Western Sydney University Innovation Hub Modification 3

Signage and stormwater infrastructure amendments
State Significant Development Modification Assessment
(SSD 9670 MOD 3)

August 2020

Published by the NSW Department of Planning, Industry and Environment

Figure 2 | Proposed Signage - South Elevation (left) and West Elevation (right) (Source: Modification Report)

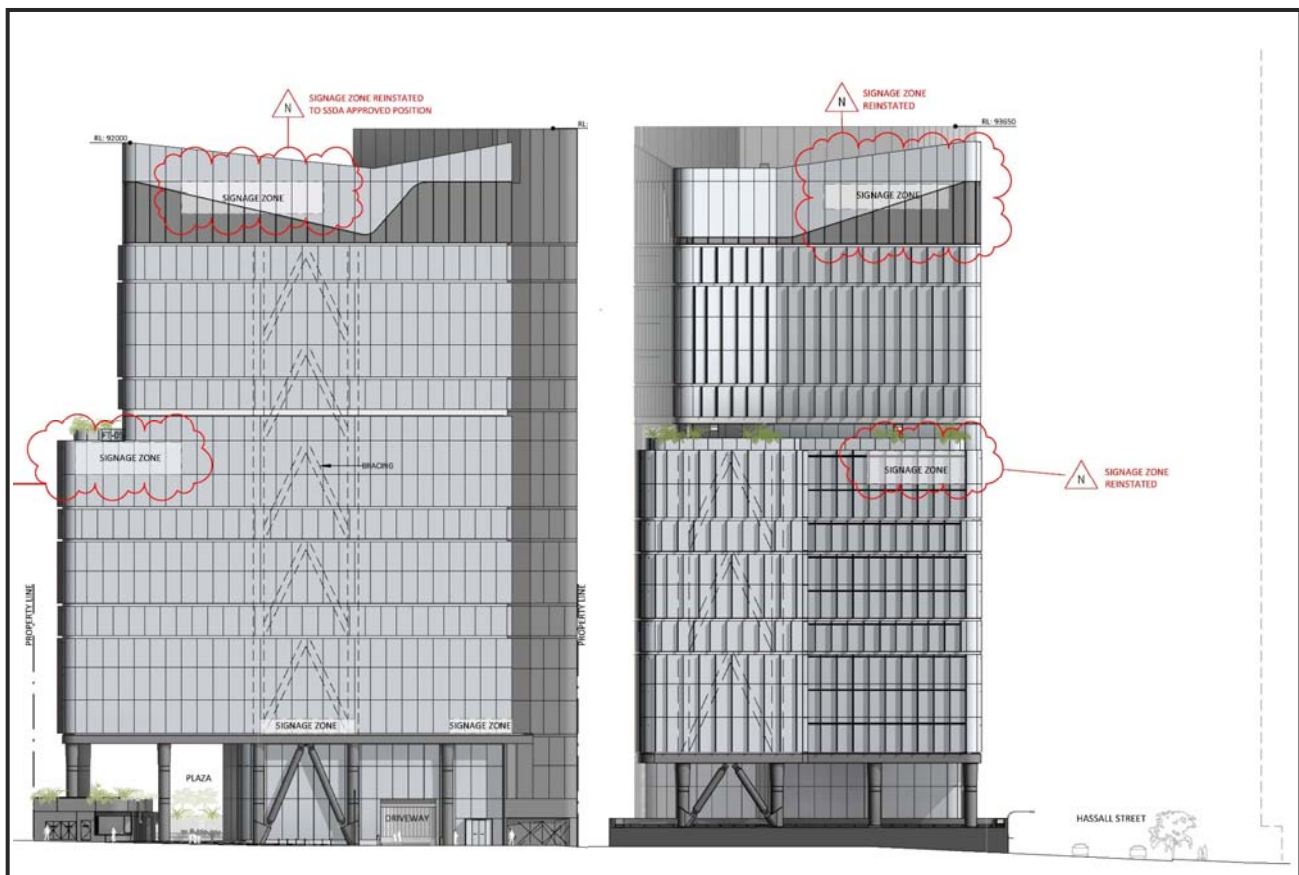
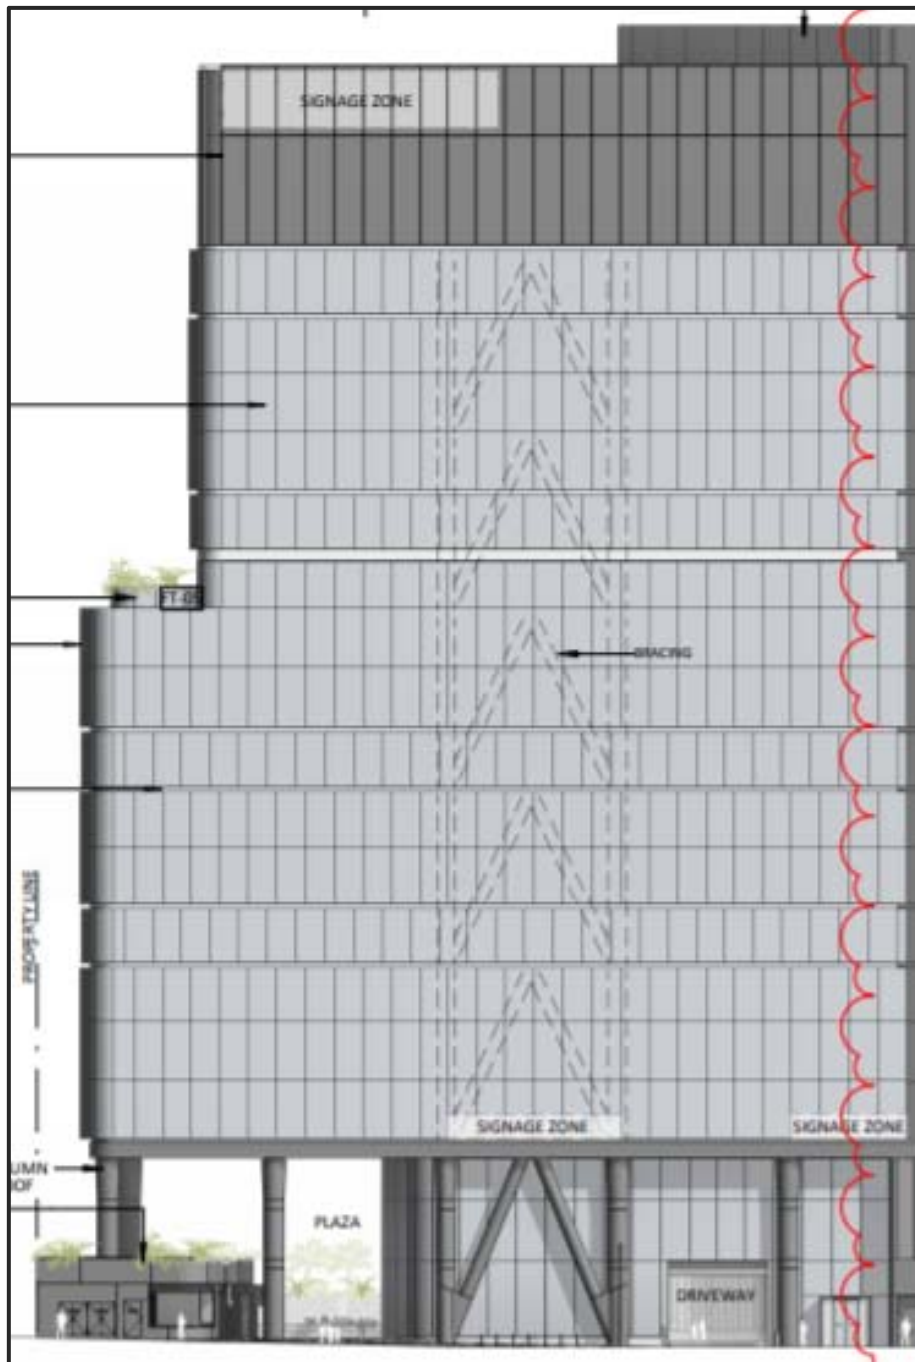
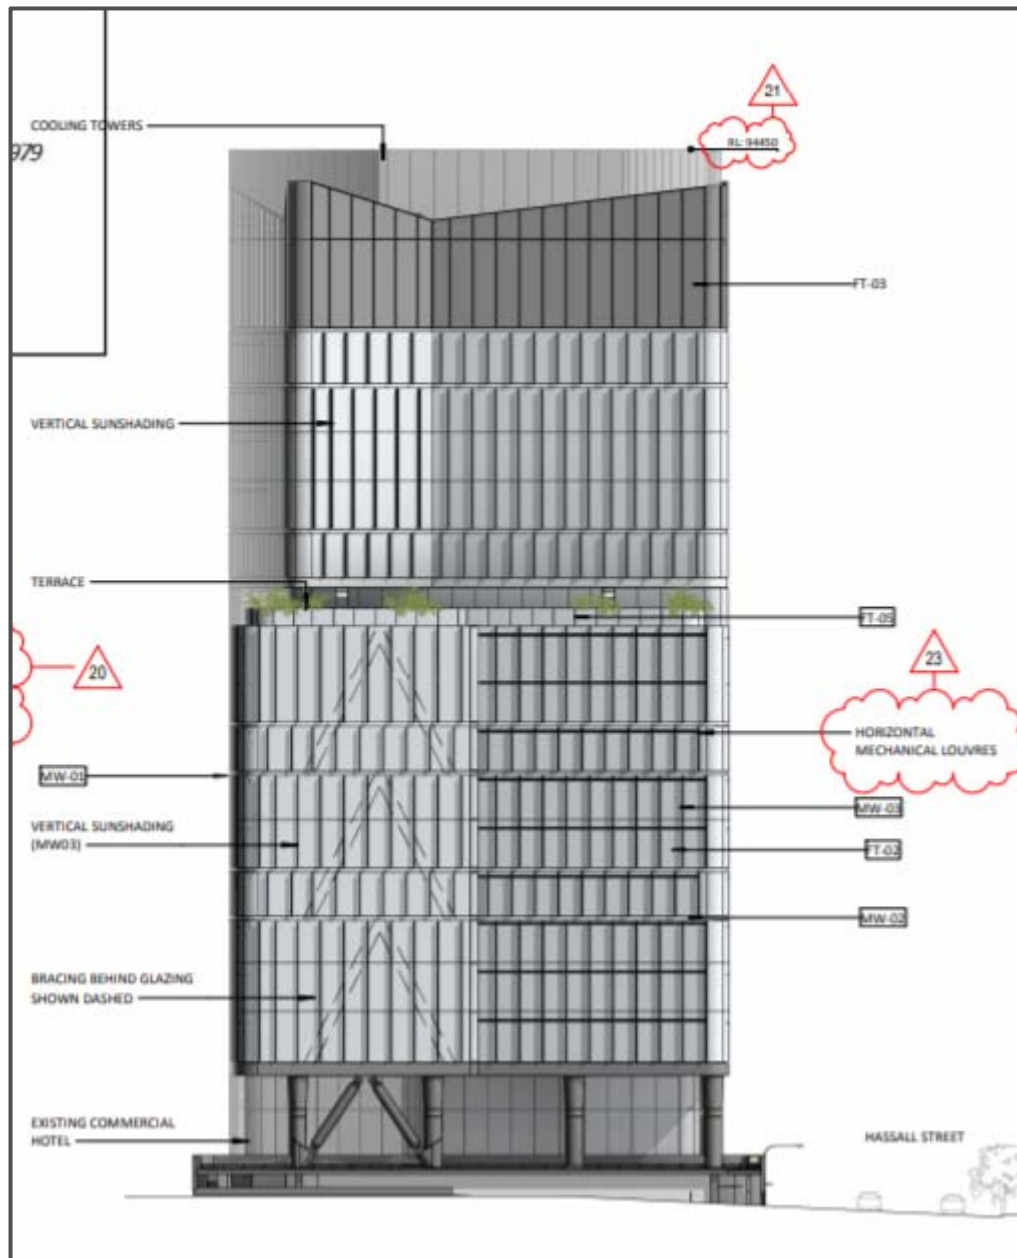
The modification application proposes to amend the building façades to include three building identification signage zones (**Figure 2**). The signage zones were included in the original SSD plans but were omitted from refined architectural plans submitted with the RtS. Two signage zones are proposed for the western elevation including one that fits within the roof parapet, which was amended under Modification 2. The second signage zone is proposed on the western elevation in the mid-rise section. A third signage zone is proposed on the southern elevation in the mid-rise section. The approved architectural southern and western elevation are shown in **Figure 3** and **Figure 4**.

The original assessment acknowledged that building identification signage zones were intended to be mounted on the building façades, but the details of the signs themselves were not included in the architectural plans in the original SSD application. The signage zones were assessed and approved under the original application despite being omitted in the RtS plans. Therefore, the signage remains consistent with the original assessment and will improve building identification for future users. The signage on the southern elevation roof parapet has been relocated further south to align with the roof parapet changes which were approved under SSD 9670 Modification 2.

The Department has reviewed the modification report and architectural plans detailing the justification for the proposed inclusion of signage on the building façades. The Department is satisfied that the signage zones were assessed and approved under the original consent and will not detract from the building design, therefore the Department is fully supportive of the amended signage zone locations as shown in **Figure 2**.
